Accessibility Survey

City of Downey Amigos Avenue - Amigos Avenue to Erickson Avenue

Prepared By
Disability Access Consultants
(800) 743-7067

City of Downey Amigos Avenue - Old River School Road to Rives Avenue

Change in Level East of Erickson Avenue @ 33.925984330057, -118.159611225128

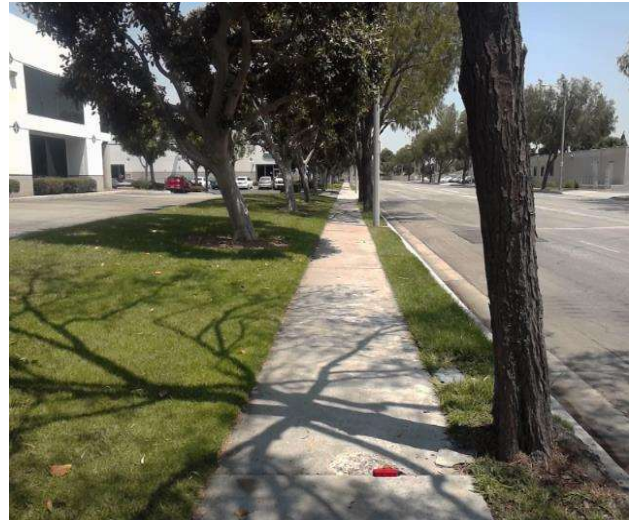
There is a change in elevation greater than recommended value.

On-Site Finding 1.50 inches

Ensure that the change in elevation is within the recommended value.

Recommendation Up to 0.25 inches

Change in Level East of Old River School Road @ 33.926291460614, - 118.160244226456

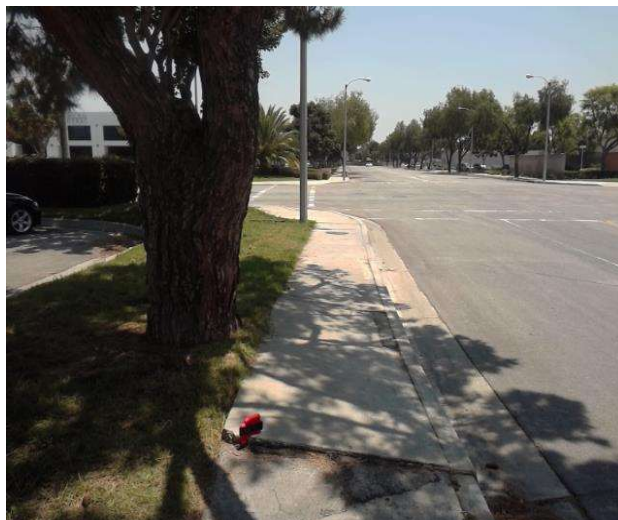
There is a change in elevation greater than recommended value.

On-Site Finding 2.00 inches

Ensure that the change in elevation is within the recommended value.

Recommendation Up to 0.25 inches

Change in Level West of Erickson Avenue @ 33.926500664852, -118.162577748299

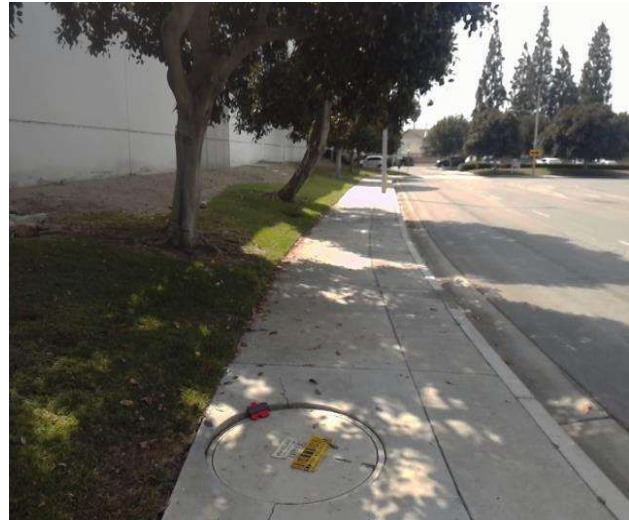
There is a change in elevation greater than recommended value.

On-Site Finding 1.75 inches

Ensure that the change in elevation is within the recommended value.

Recommendation Up to 0.25 inches

Change in Level East of Erickson Avenue @ 33.925192017132, -118.158023357391

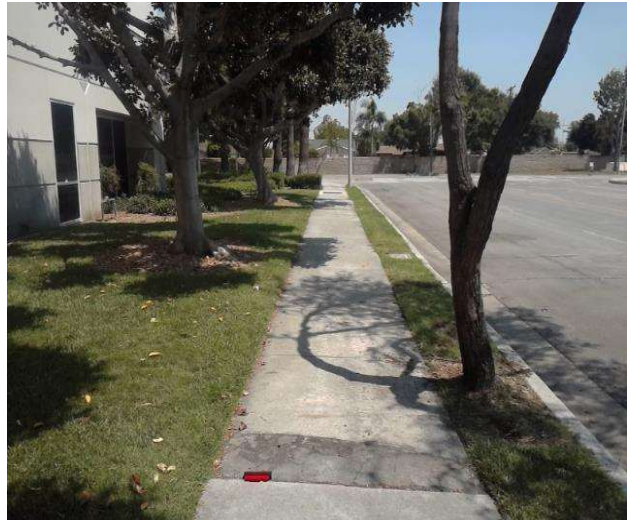
There is a change in elevation greater than recommended value.

On-Site Finding 0.50 inches

Ensure that the change in elevation is within the recommended value.

Recommendation Up to 0.25 inches

Change in Level East of Erickson Avenue @ 33.925267687786, -118.158184289932

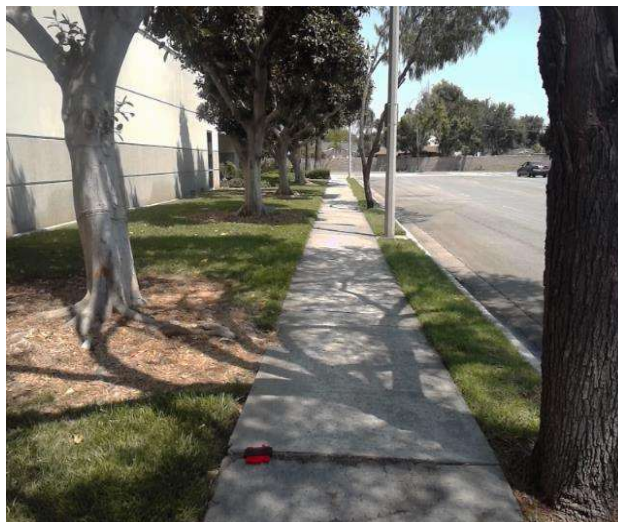
There is a change in elevation greater than recommended value.

On-Site Finding 0.75 inches

Ensure that the change in elevation is within the recommended value.

Recommendation Up to 0.25 inches

Change in Level East of Erickson Avenue @ 33.925899757681, -118.159428834915

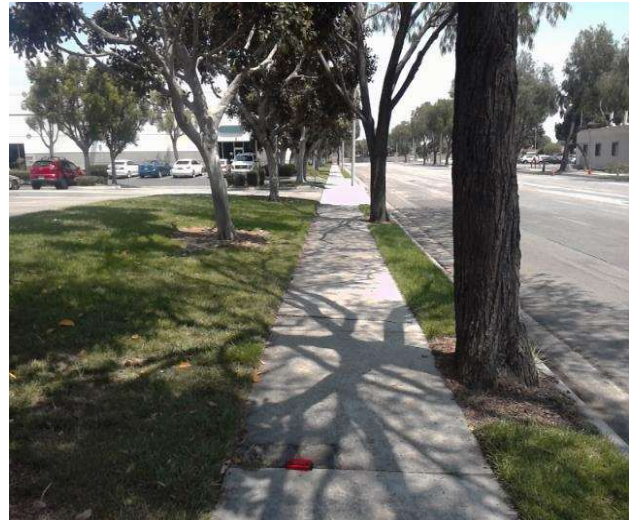
There is a change in elevation greater than recommended value.

On-Site Finding 0.50 inches

Ensure that the change in elevation is within the recommended value.

Recommendation Up to 0.25 inches

Change in Level East of Old River School Road @ 33.926335972197, - 118.160330057144

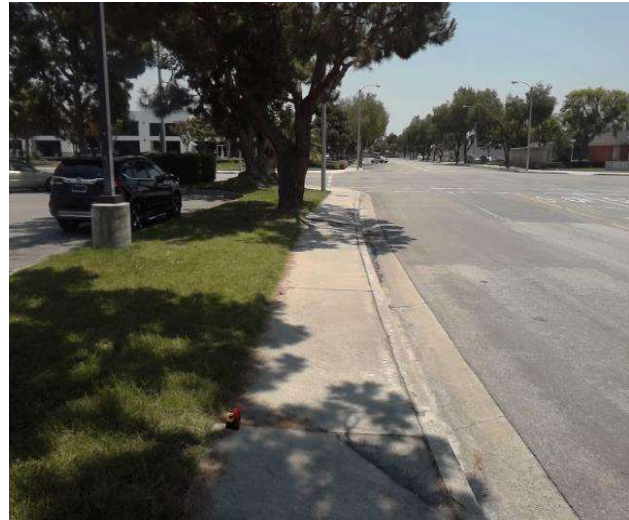
There is a change in elevation greater than recommended value.

On-Site Finding 0.75 inches

Ensure that the change in elevation is within the recommended value.

Recommendation Up to 0.25 inches

Change in Level East of Old River School Road @ 33.926460604506, - 118.160796761513

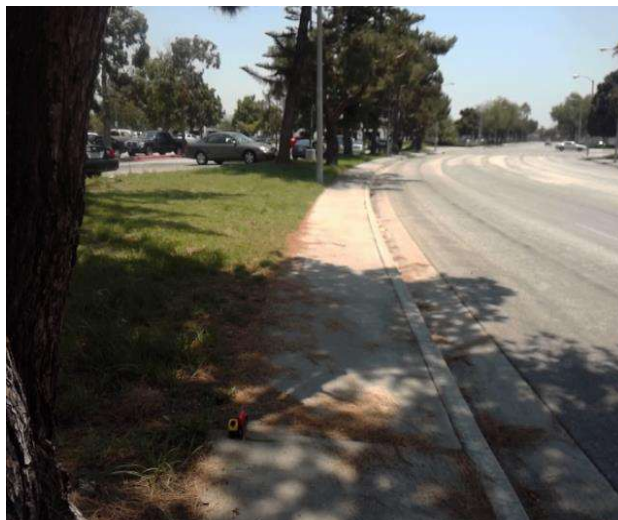
There is a change in elevation greater than recommended value.

On-Site Finding 1.25 inches

Ensure that the change in elevation is within the recommended value.

Recommendation Up to 0.25 inches

Change in Level East of Old River School Road @ 33.926509567148, - 118.161156177521

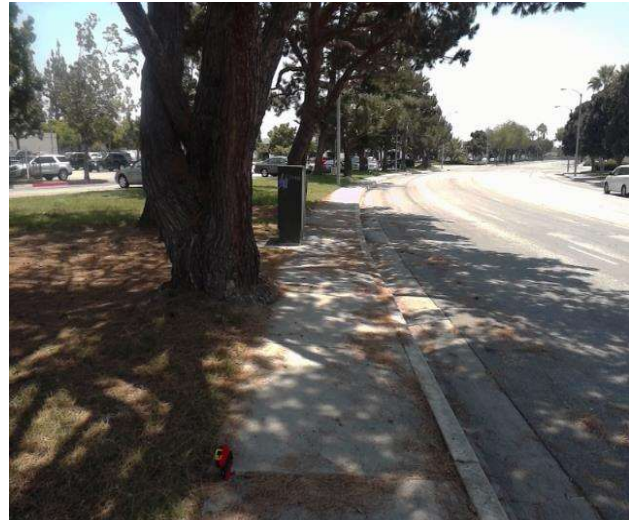
There is a change in elevation greater than recommended value.

On-Site Finding 0.75 inches

Ensure that the change in elevation is within the recommended value.

Change in Level West of Erickson Avenue @ 33.926438348750, -118.162379264832

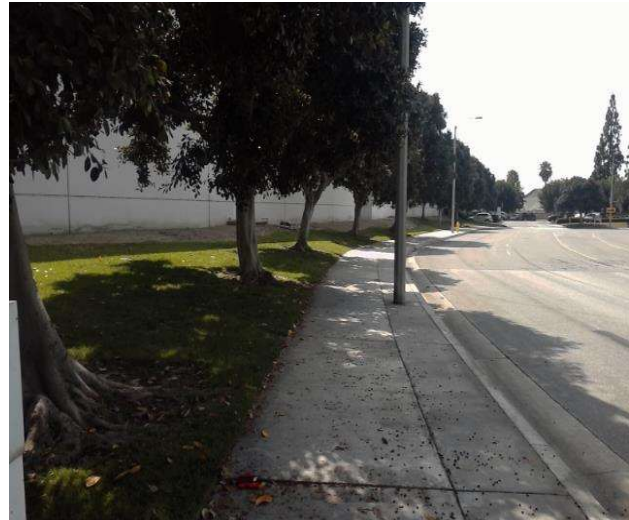
There is a change in elevation greater than recommended value.

On-Site Finding 1.00 inches

Ensure that the change in elevation is within the recommended value.

Change in Level West of Rives Avenue @ 33.924951651079, -118.158039450645

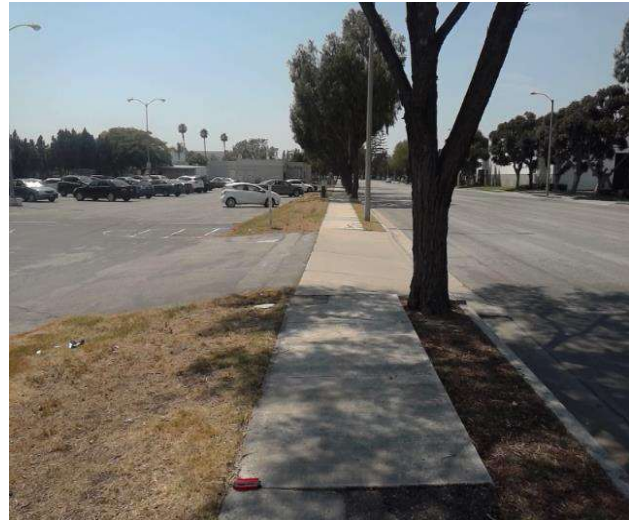
There is a change in elevation greater than recommended value.

On-Site Finding 0.50 inches

Ensure that the change in elevation is within the recommended value.

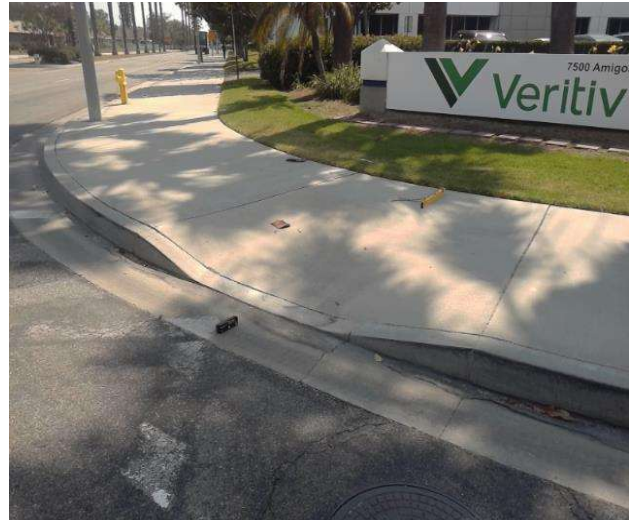
The bottom landing of the curb ramp is on the street, and the slope of the bottom landing is not compliant.

On-Site Finding 6.50 percent

Ensure the bottom landing slope is compliant and provides a smooth transition.

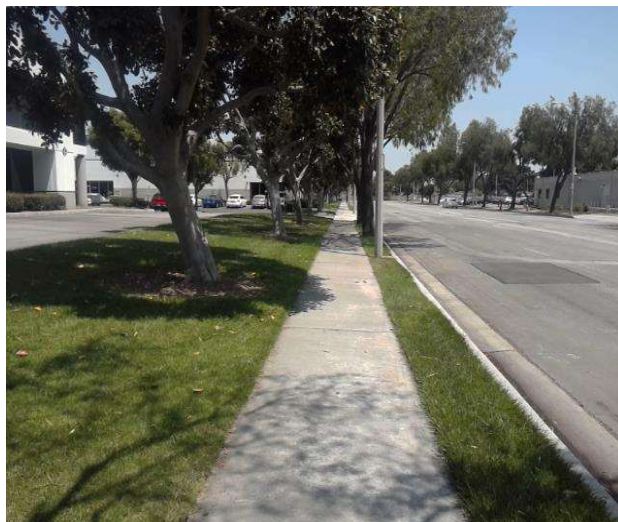
Sidewalk cross slope is not compliant.

On-Site Finding 4.90 percent for 80.00 feet

Repave the sidewalk surface with the recommended cross slope.

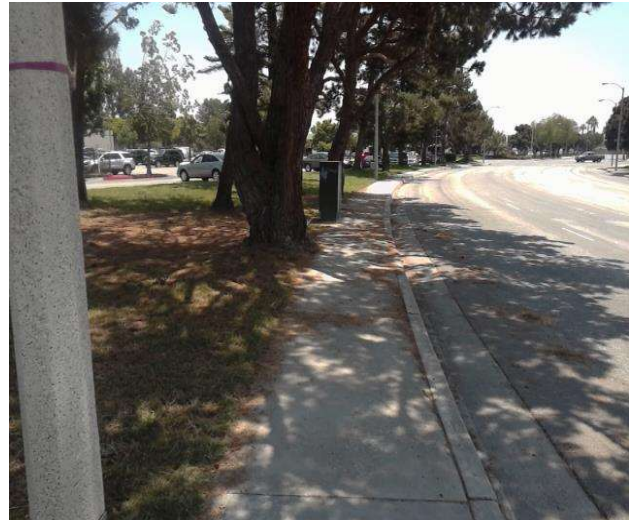
Sidewalk cross slope is not compliant.

On-Site Finding 7.20 percent for 150.00 feet

Repave the sidewalk surface with the recommended cross slope.

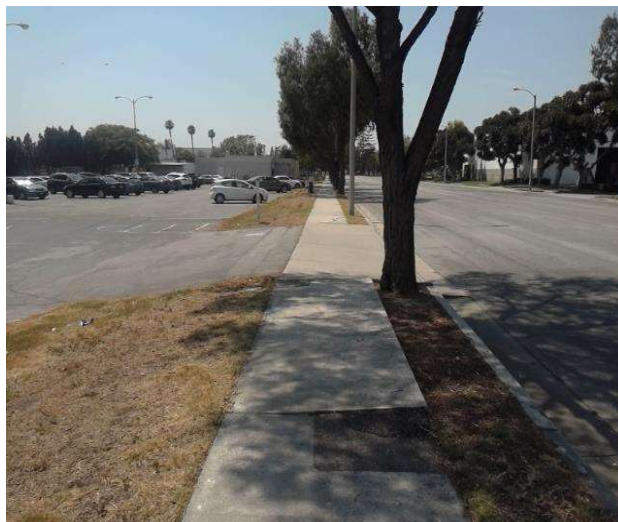
Sidewalk cross slope is not compliant.

On-Site Finding 4.70 percent for 15.00 feet

Repave the sidewalk surface with the recommended cross slope.

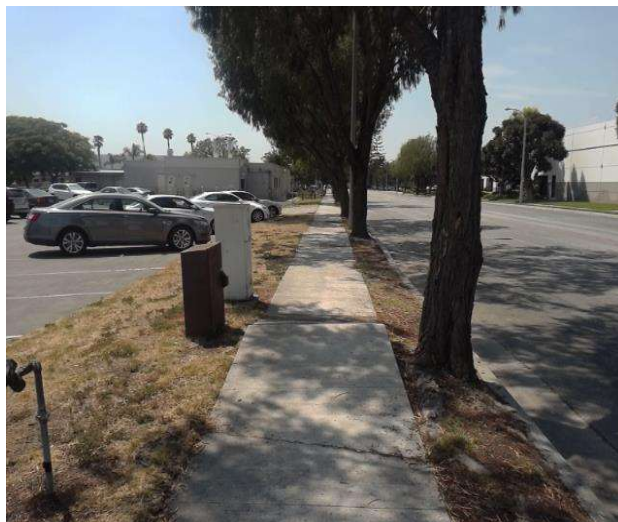
Sidewalk running slope is not compliant.

On-Site Finding 20.20 percent for 7.00 feet

Repave the sidewalk surface with the recommended running slope.
